**Subject: Notification of Class 1 Permit Modification Facility Description Updates for the Technical Area 63 Transuranic Waste Facility Container Storage Unit, Los Alamos National Laboratory Hazardous Waste Facility Permit, EPA I.D. #NM0890010515 (NA/LA)**

**Class 1 Permit Modification  
Facility Description Updates for the  
Technical Area 63 Transuranic Waste Facility  
Container Storage Unit,  
Los Alamos National Laboratory  
Hazardous Waste Facility Permit**

**EPC-DO: 17-196**

**DWG-102355-C55443-C-1017, *Retention Basin Foundation Plan***

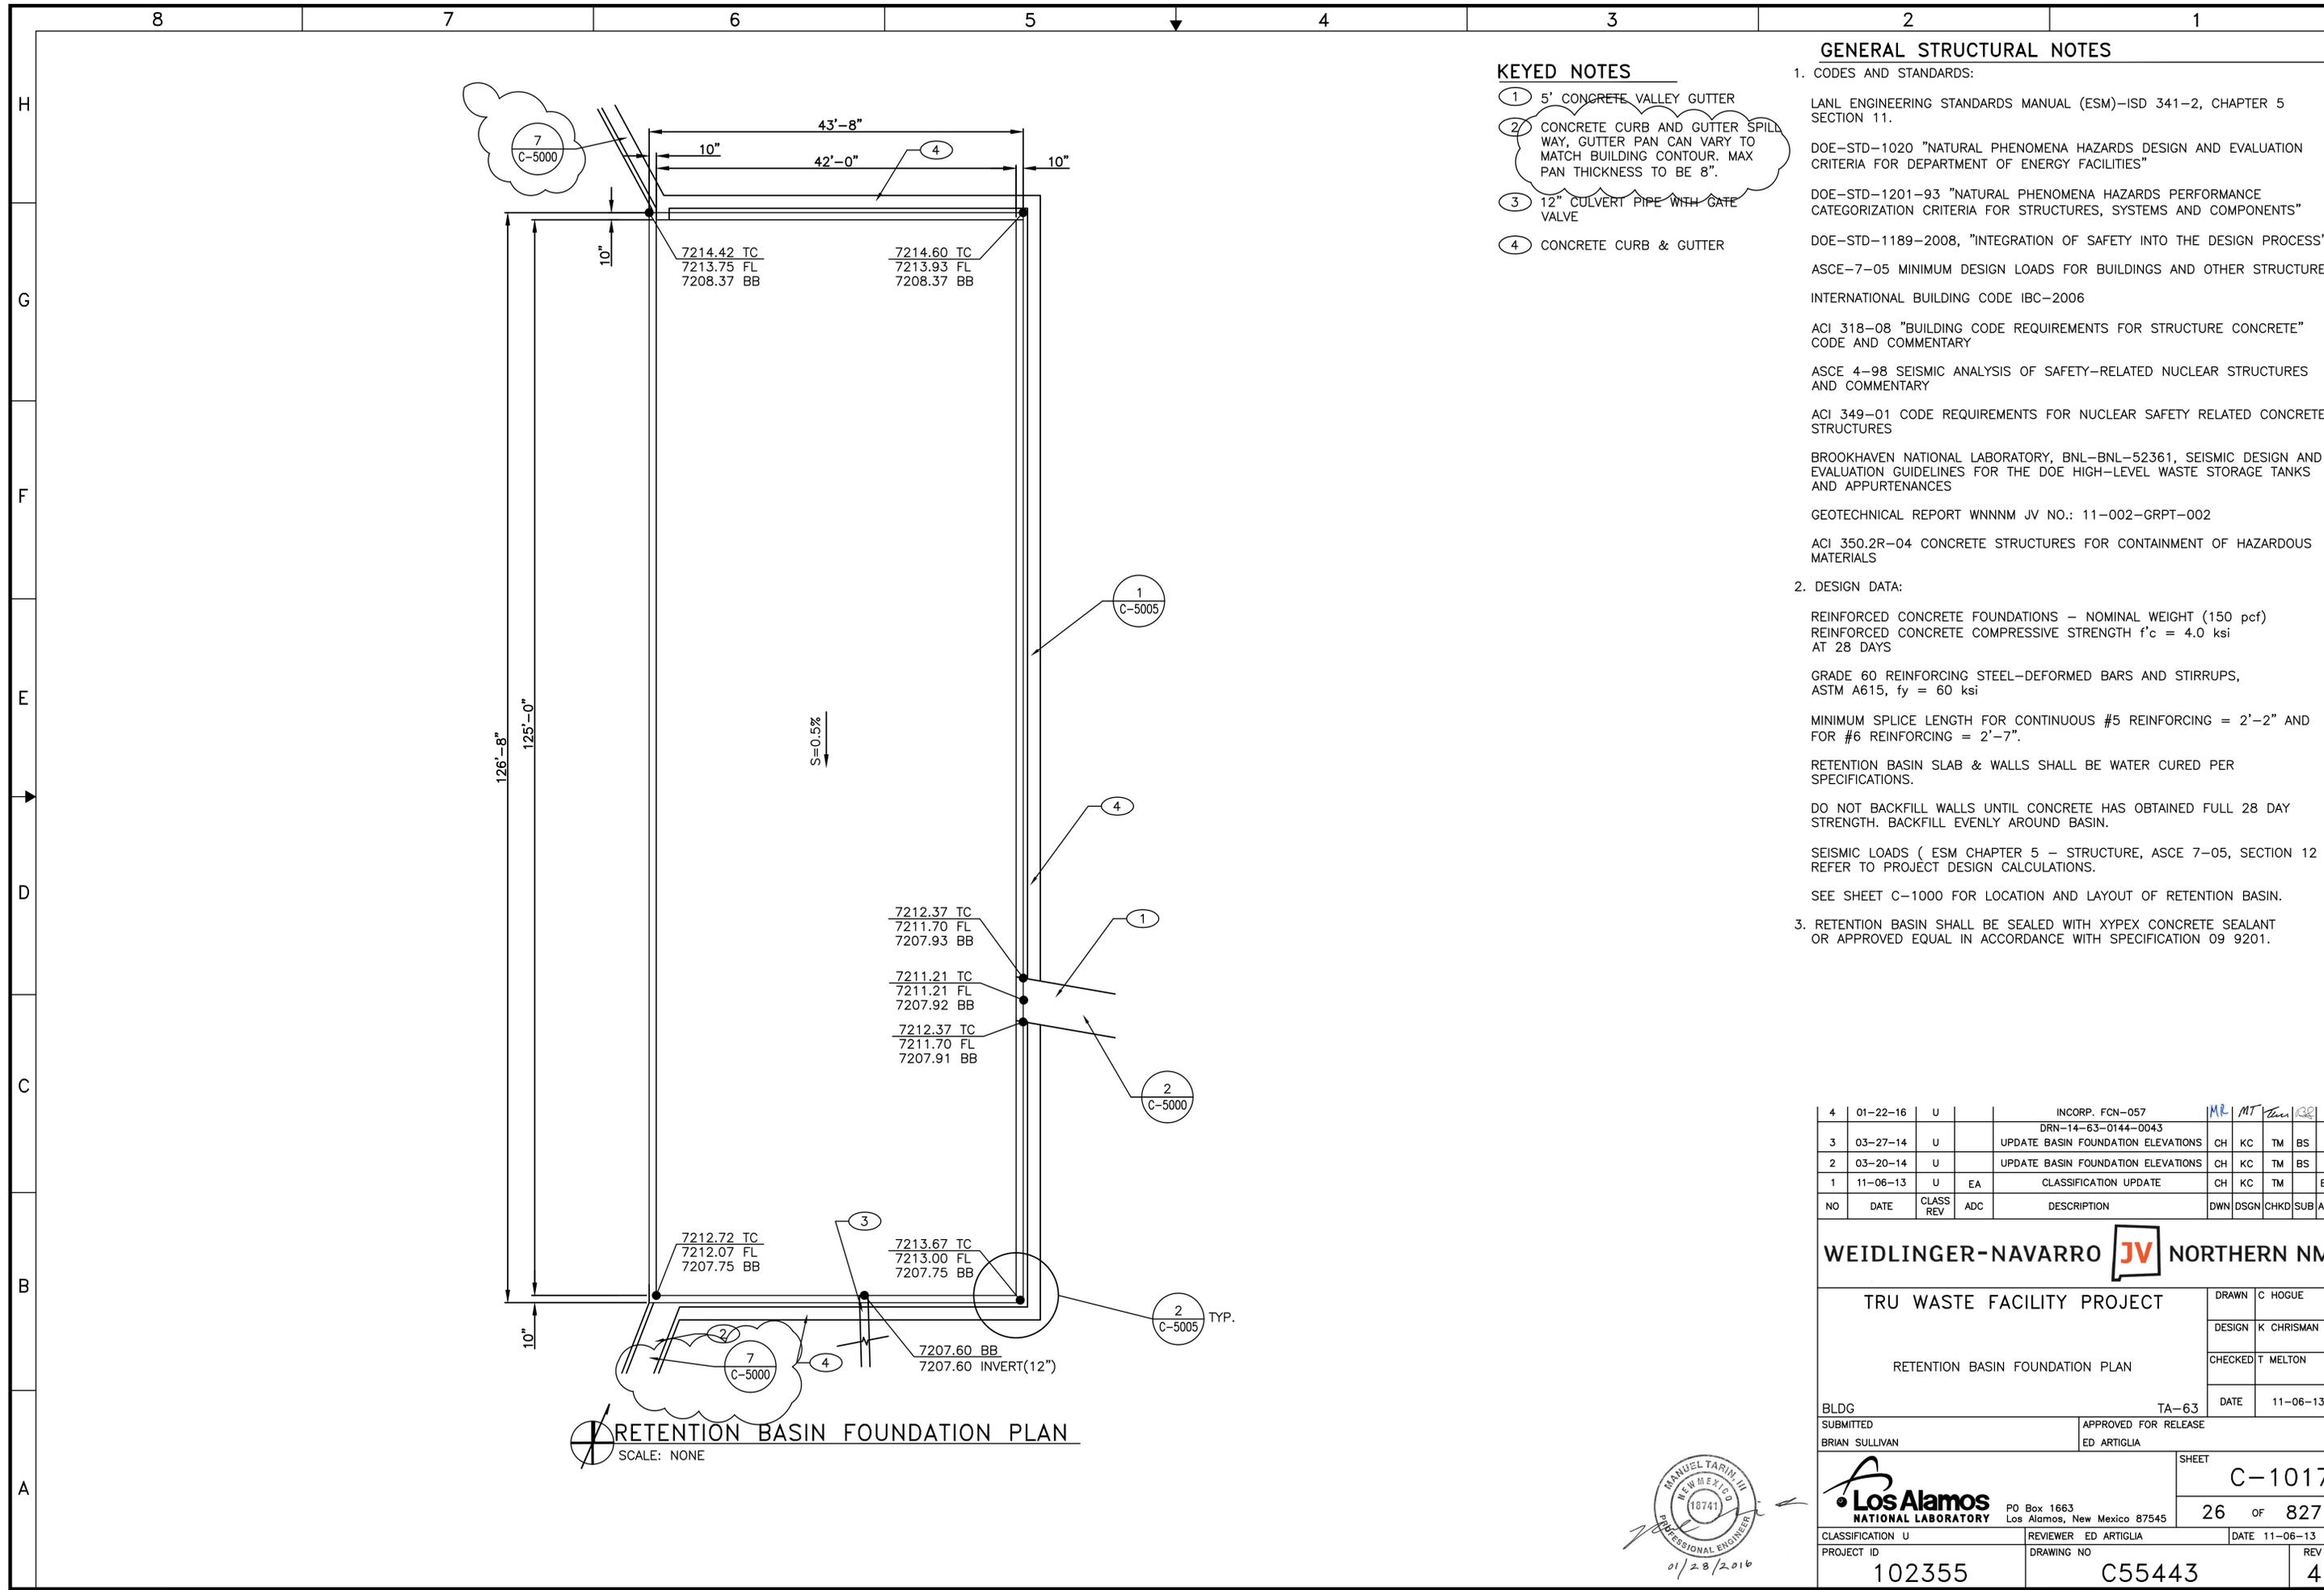
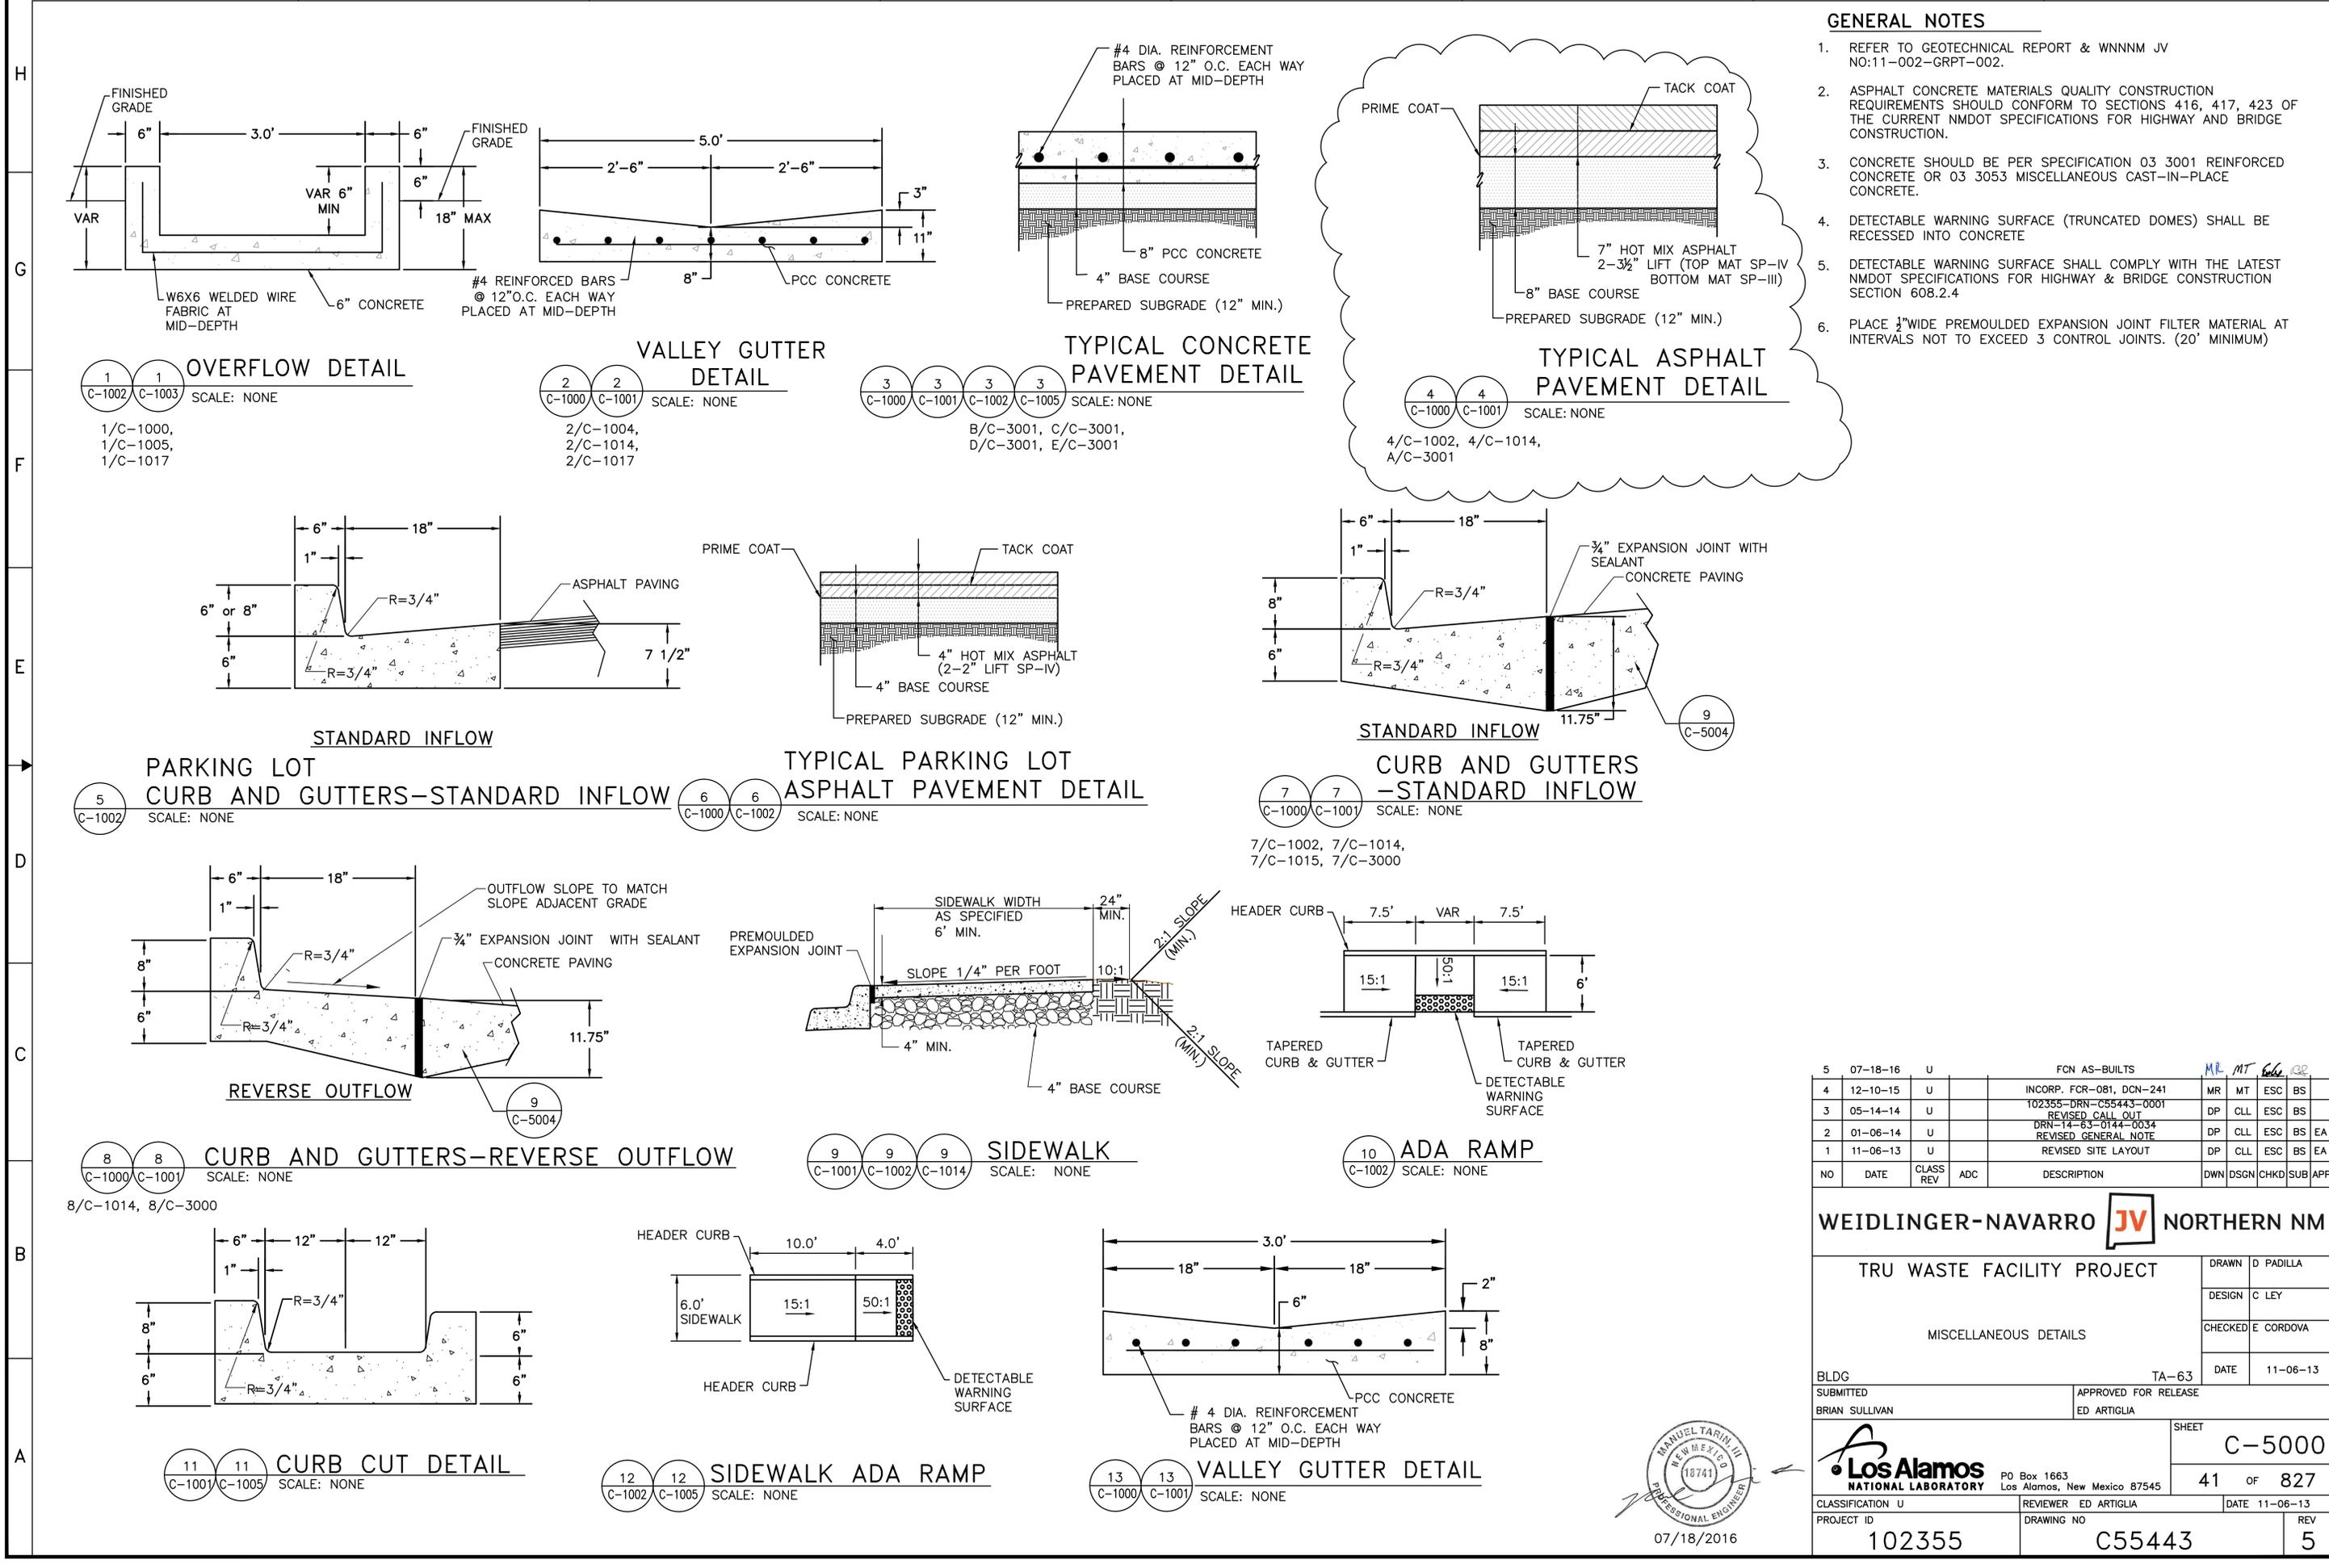
The discussion of the design capacity for the TA-63 TWF retention basin requires a text correction. The retention basin dimensions described in Permit Attachment A, *Unit Descriptions*, Section A.6.5, *Retention Basin*, were revised by the 2014 Permit modification (LANL, 2014) as the designed depth had been changed due to an alteration of the original slope of the retention basin floor. The total designed volume capacity of 137,450 gallons was not changed but the depth increase indicated a 1 foot freeboard rather than the 0.5 foot freeboard originally given in the discussion. The revised section contains a sentence that states: “The designed total retention basin volume also includes 1.0 ft. of freeboard, resulting in a total capacity of 137,450 gallons...” This revision did not address the 6 inch depth of the overflow curbing cut-out in the south west corner of the retention basin. Subtracting the depth of the

overflow cut-out corrects the freeboard height description to 0.5 feet and the sentence has now been altered to state that in this modification. This change does not affect the designed retention basin capacity. Attachment 1 of this document includes two figure drawings with the general plan of the retention basin and the construction detail showing the dimensions for the overflow. It also includes a photograph of the overflow curbing cutout and the text revision for Permit Section A.6.5.

**FIGURE 55.**

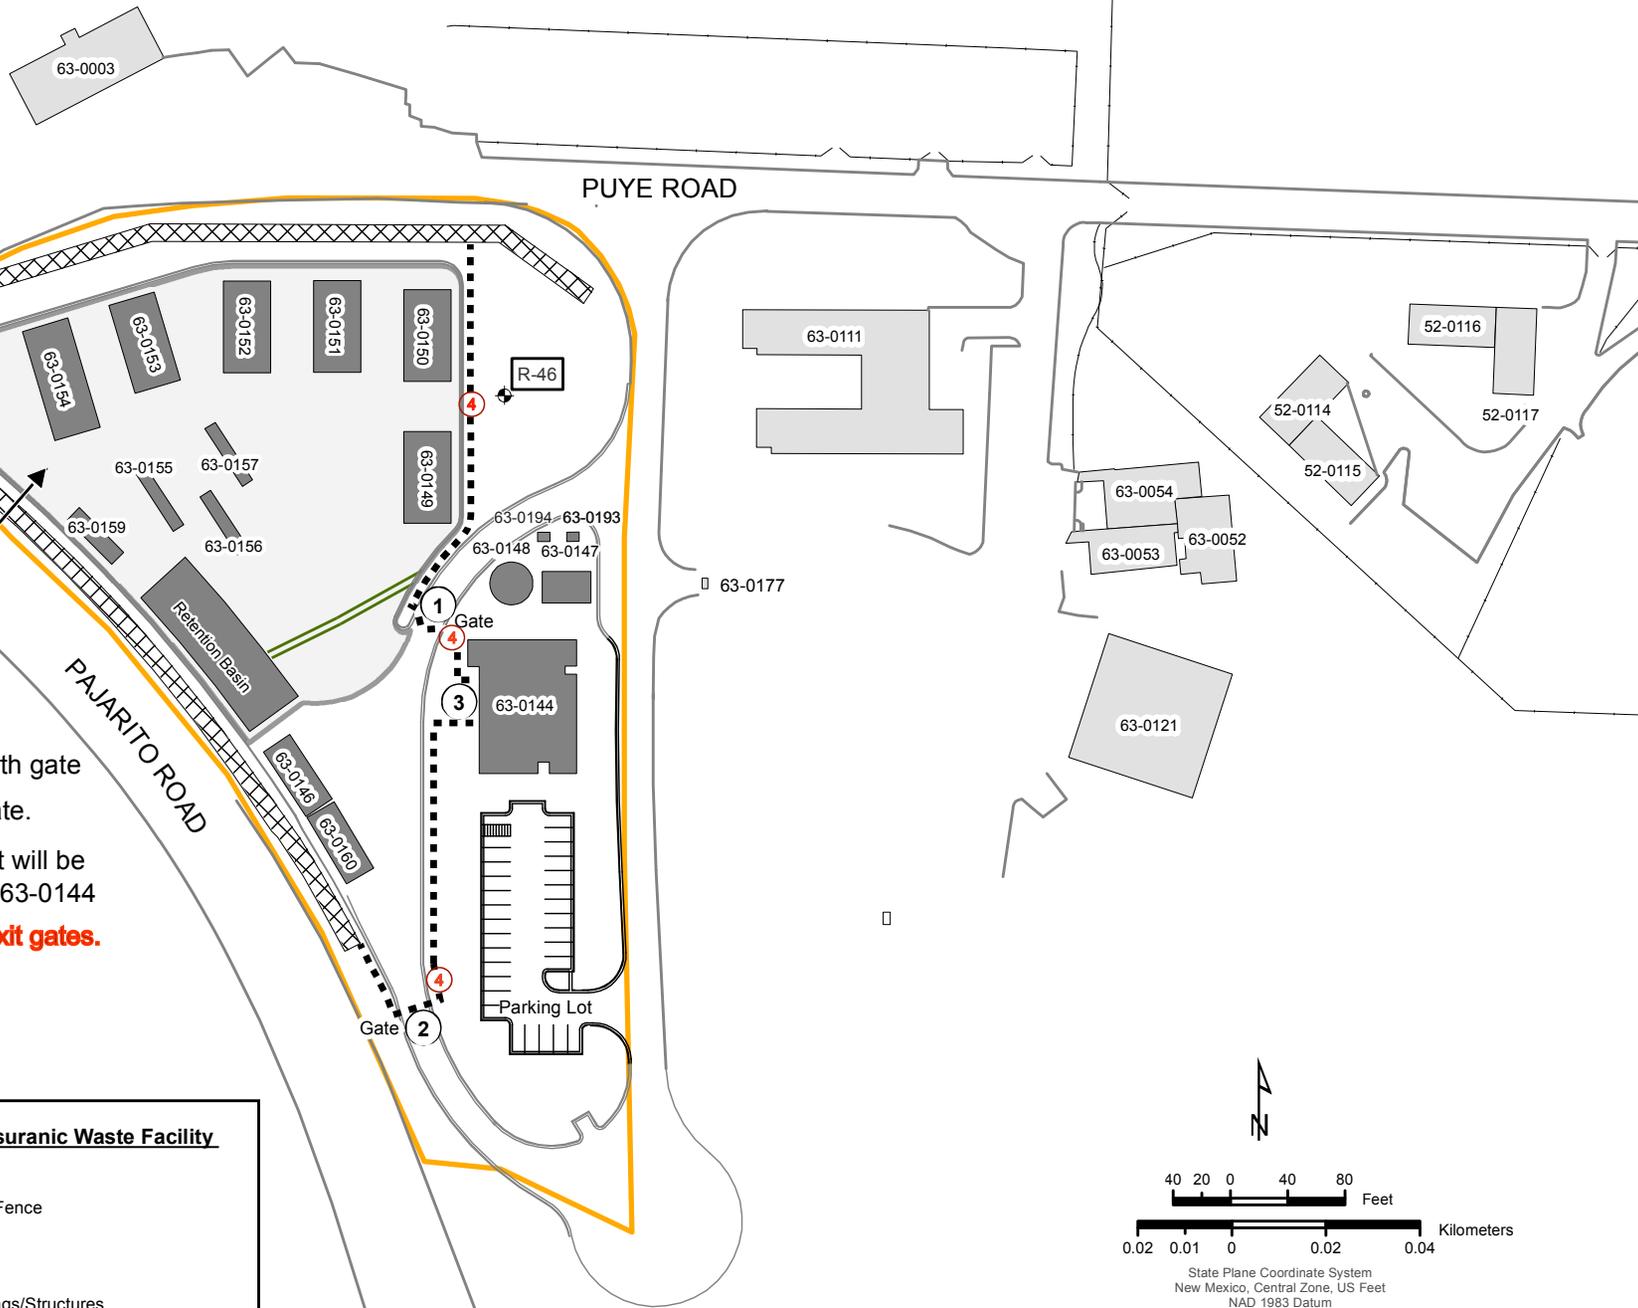
Three emergency personnel exit gates (crash gates) are present in the security fence as constructed for the TA-63 TWF on the east and south sides. These gates are opened from the inside of the fence line for the purpose of aiding the exit of personnel in emergency situations. They are not routinely kept open for any other purpose and are a security feature of the fence because they cannot be opened from the outside. Figure 55, *Technical Area (TA) 63 Transuranic Waste Facility* and Permit Section A.6.7, *Security and Access Control*, are revised to include the gates in the facility description and provide their locations. Revision details are included in Attachment 3. Figure 55 has been modified to show the location of the three gates and a descriptive note has been added. A sentence has been added to Permit Section A.6.7 stating:

“Three emergency personnel one-way exit gates are also present in the fence.” Attachment 3 also includes a facility construction figure with gate details previously submitted in the TA-63 TWF Construction Notice (LANL, 2017).

- ① Vehicle entrance via north gate
- ② Vehicle exit via south gate.
- ③ Personnel entry and exit will be via Operations Building 63-0144
- ④ **Emergency personnel exit gates.**
